Access Compliance Report Public Rights-of-Way (Curb Ramps)

Main Street: STOLLER_LN Cross Street: CRAWFORD_CANYON_RD Location: NW

ADA ID: RPRK211007173321 Ramp Type: Type 1 - Perpendicular Diagonal Initial Pass/Fail: Fail Overall Compliance: No Severity Score: 60

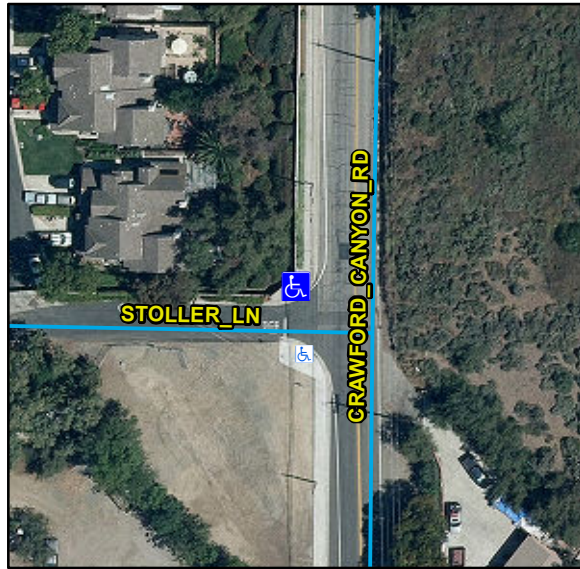
Possible Solutions:

Remove & Replace Curb Ramp With Two New Directional Ramps or Equivalent.

R304.2.2, R204.3, R304.5.3, R302.7.2, STD 1115
